NARKOMED 6000
TECHNICAL SERVICE BULLETIN # 6002

Re: **Vitalbus Hub J-13 connector orientation**

Figure-1 Vitalbus HUB J-13 Connector Orientation

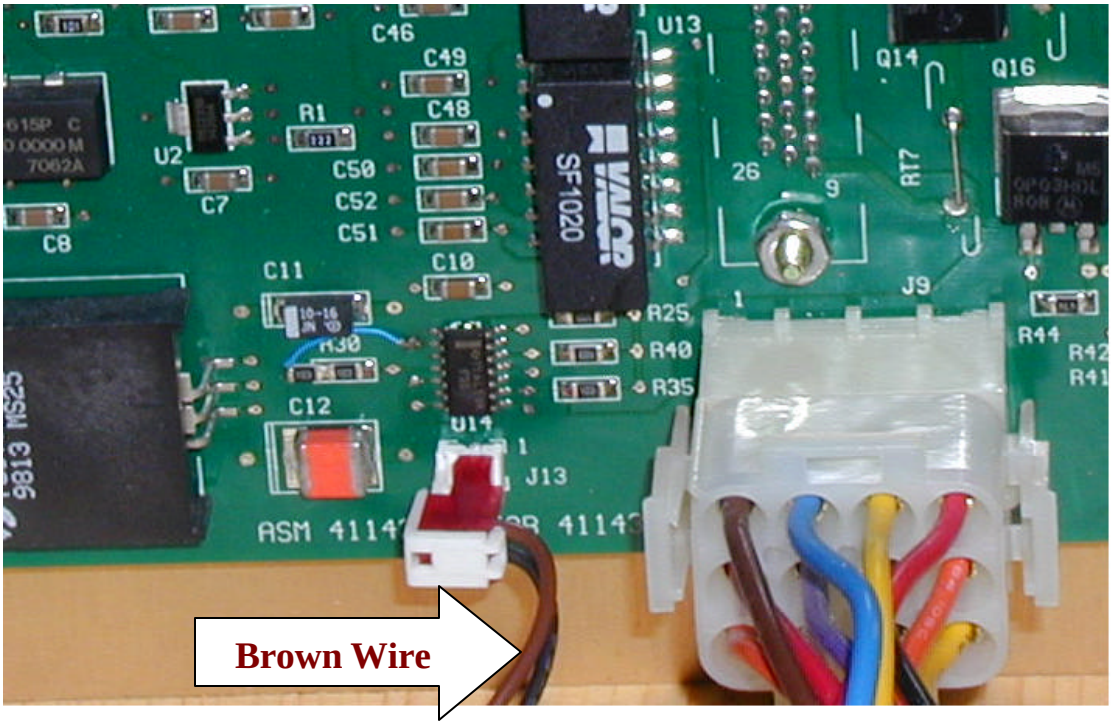
Reason/Rational: To ensure proper installation of the small 2-pin wire harness at J-13 of the Vitalbus Hub PCB after repair or service work is performed. Incorrect orientation of this polarity sensitive cable will cause a system failure that may not be immediately recognized.

Solution/Procedure: When re-attaching the 2-pin wire harness to Vitalbus HUB at J-13, verify it's proper orientation. From the header connector the lead wires must route to the right and the brown wire must positioned above the black wire. See attached illustration Figure 1. Also refer to Narkomed 6000 Technical Service manual Replacement Procedures, Section - 4 for complete servicing instructions.
